Project Name | BCWD Permit #25-30 Brixton Townhomes

Regarding | Site Plan and Amenity Updates

Project Name	BCWD Permit 25-30 Brixton Townhomes	Date	2/17/2026
To / Contact info	BCWD Board of Managers		
Cc / Contact info	Dan Sjoblom, PE / Alliant Engineering		
Cc / Contact info	Karen Kill, Administrator / BCWD		
From / Contact info	Paul Nation, PE; Julia Lau, EIT / EOR		
Regarding	Permit Application No. 25-30 Engineer's Report

Figure 1: Proposed Site Plan

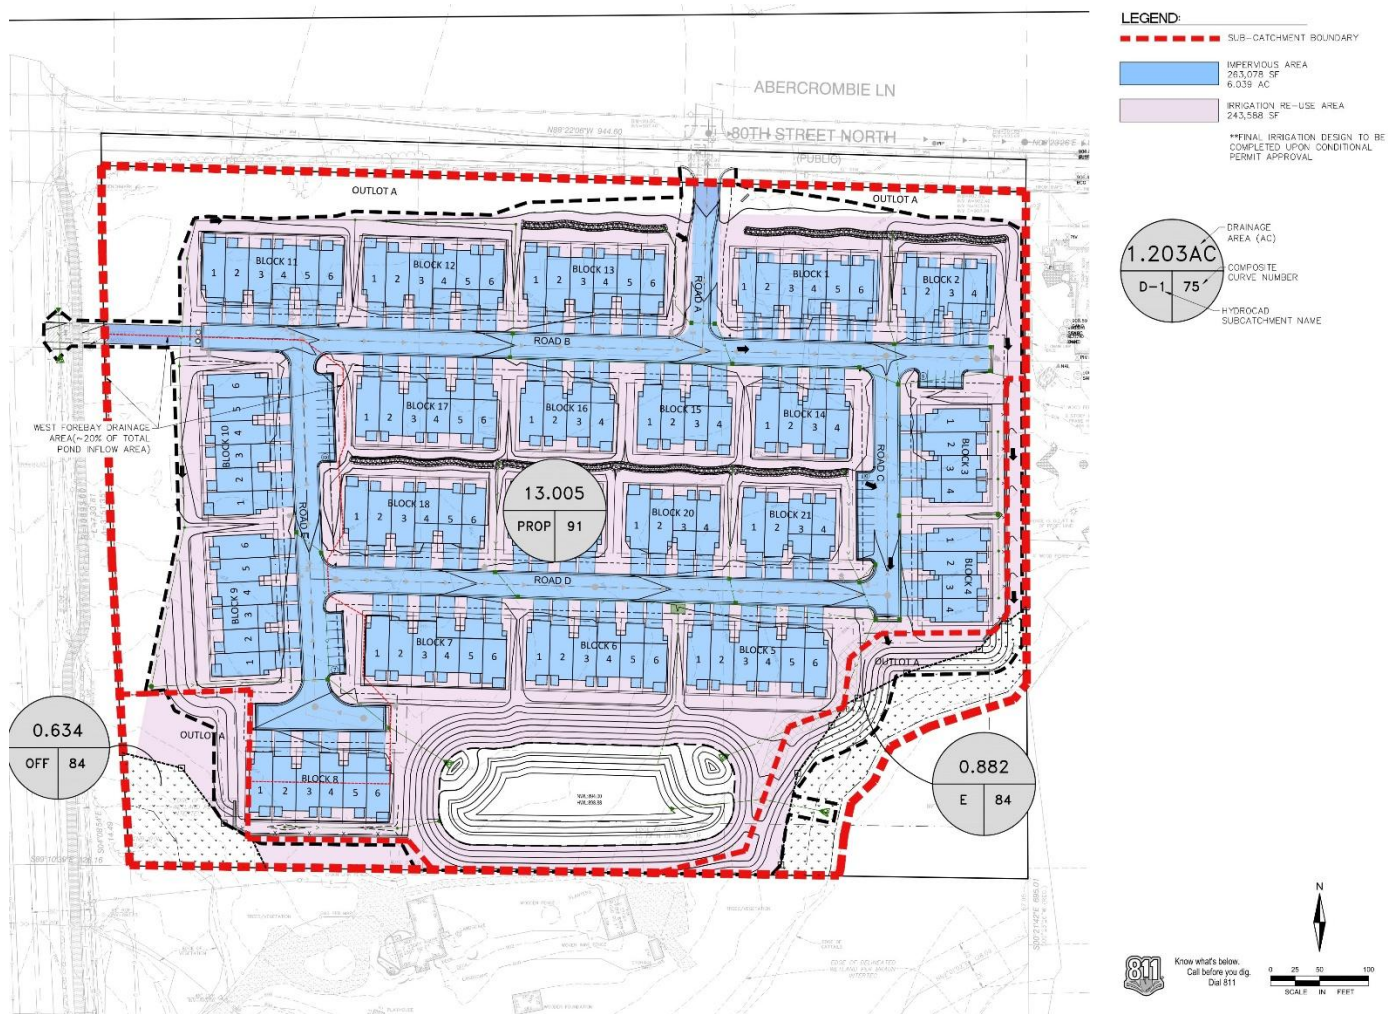
Proposed Conditions: The applicant proposes construction of 21 townhome blocks, seven tree trenches, bituminous roadways, 0.61 acres of native vegetative buffers, and an irrigation reuse pond with irrigation system. (Figure 1). The general flow pattern would remain from north to south and into the adjacent wetlands to the south. The project would disturb 12.43 acres, and the total proposed impervious area would be 6.83 acres (47.0%).
